RECEIPT DATE: 12/18/18 **ONSITE SEWAGE DISPOSAL SYSTEM** P 564703

APPROVAL DATE: 12/21/2018 **PERMIT:** REPAIR A _____

PROPERTY ADDRESS: 11855 Lime Kiln Road

LOCATION DIAGRAM

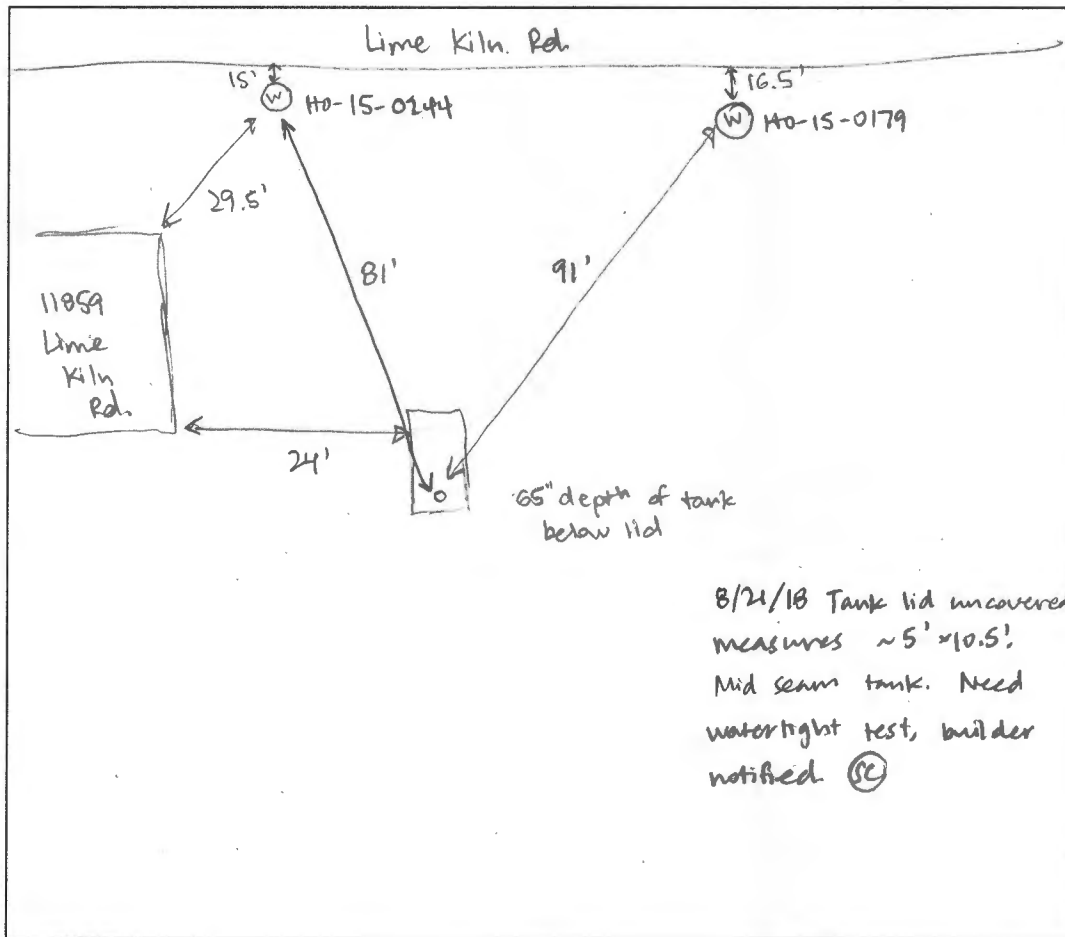
COMMENTS: Tank was full at pumping. Freedom septic on site. 6" clo at rear of tank, ~2' of cover on top of tank. Rear baffle seen from clo. Freedom estimated at least 1500 gal sewage pumped out from level at sight glass on pump truck. Lid of tank not fully uncovered, can't get measurements. Spoke w/ Steve Forney on site, he will have it uncovered.

* Home
 on
 11855

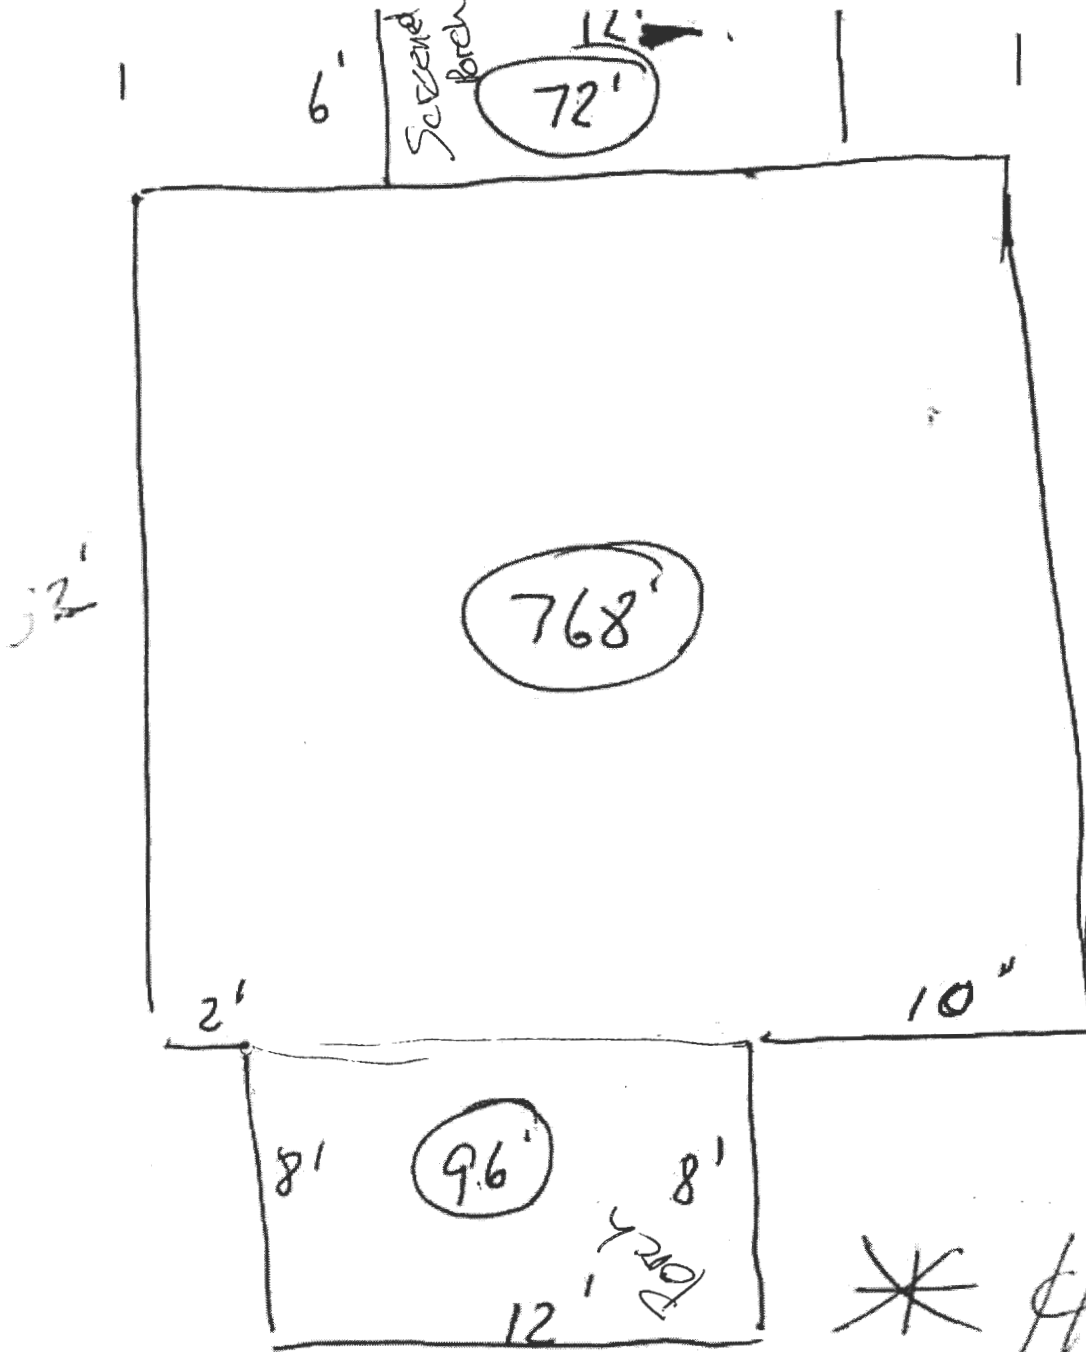
Hello Stephen. I reviewed the plans you dropped off. As referenced in the email below, the only way to avoid the requirements for upgrade of the existing sewage disposal system or establishment of a sewage disposal area is to not increase square footage, number of bedrooms, or living space.

The proposal you sent to me appears to increase the square footage and living space compared to the existing. What you sent was a bit unclear, but is the existing basement finished or unfinished? You list the existing 1st and 2nd floor at 1320 sq ft. Your proposed house is 1734 sq ft not counting any basement (is there a basement and is it finished?). Any increase in square footage or living space or bedroom count would trigger the requirement for a sewage disposal area and this property does not have an approved sewage disposal area as long as the property at 8020 Hunterbrooke still has the existing downgrade well. An increase in living space or bedroom count would also trigger a requirement to upgrade the sewage disposal system with a BAT unit, which cannot happen until the disposal area is able to be used after the well at 8020 Hunterbrooke is relocated.

Lastly, before we could approve any building permit, we would need to have the existing septic tank located, pumped out, and inspected for its condition and construction. If it were of a construction that could be a public health nuisance, such as a metal tank, we would require that to be changed. We would also need to see that exact tank location on the plot plan to ensure that the new house location is at least 20' away.

Plan 630 A

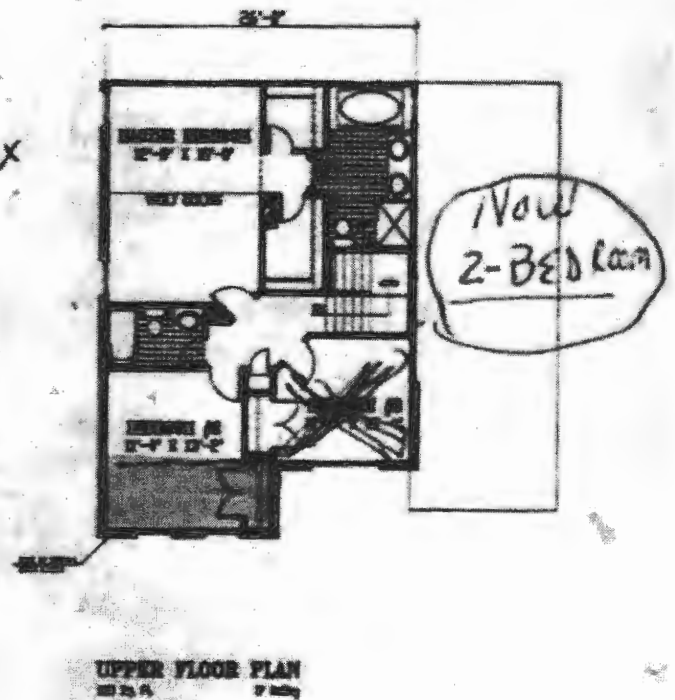
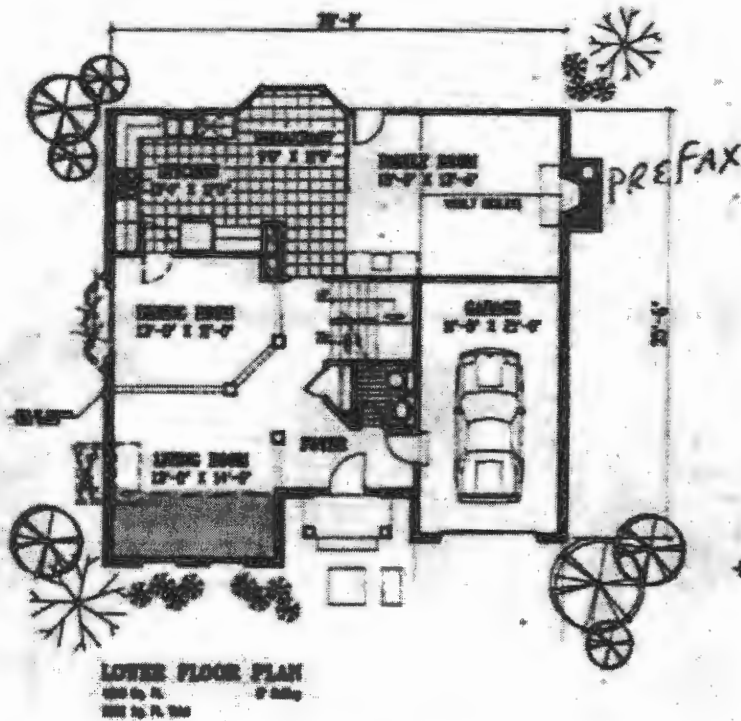
WAS 2002' Now 1734'

The proposal you sent to me appears to increase the square footage and living space compared to the existing. What you sent was a bit unclear, but is the existing basement finished or unfinished? You list the existing 1st and 2nd floor at 1320 sq ft. Your proposed house is 1734 sq ft not counting any basement (is there a basement and is it finished?). Any increase in square footage or living space or bedroom count would trigger the requirement for a sewage disposal area and this property does not have an approved sewage disposal area as long as the property at 8020 Hunterbrooke still has the existing downgrade well. An increase in living space or bedroom count would also trigger a requirement to upgrade the sewage disposal system with a BAT unit, which cannot happen until the disposal area is able to be used after the well at 8020 Hunterbrooke is relocated.
